REMARKS

Applicant : Noriyasu Sakai et al.
Serial No. : 10/667,681
Filed : September 22, 2003
Page : 15 of 15

Amendments to the Drawings:

FIG.13A

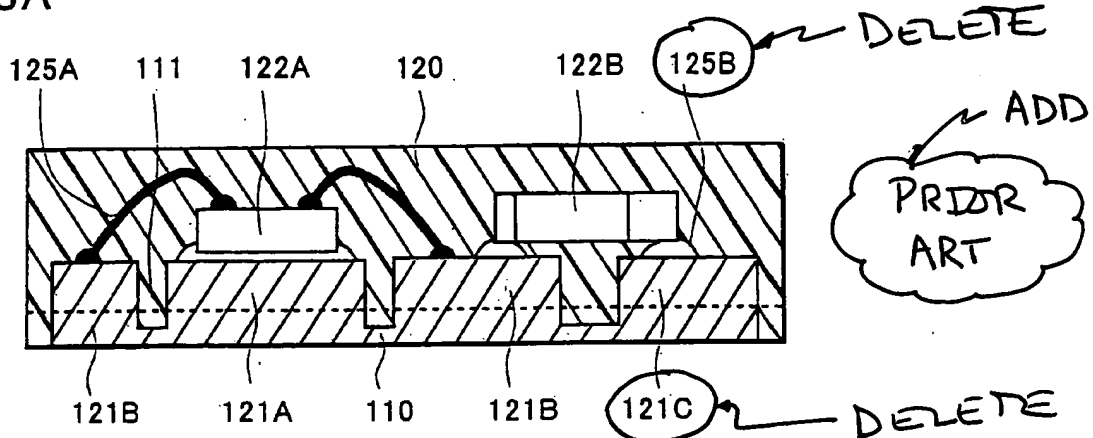
The Office Action indicated that FIGs. 13A-13C should be designated by a legend such as --Prior Art-- because only that which is old is illustrated. Applicants have amended Figs. 13A-13C to include that designation.

The drawings were objected to because certain reference numerals were identified in FIGs. 13A-13C, but were not identified in the specification. Applicants have deleted those reference numbers from FIGs. 13A-13C and request acceptance of FIGs. 13a-13c.

In Figure 13A, reference numerals 121C and 125B have been deleted and the designation "Prior Art" has been added.
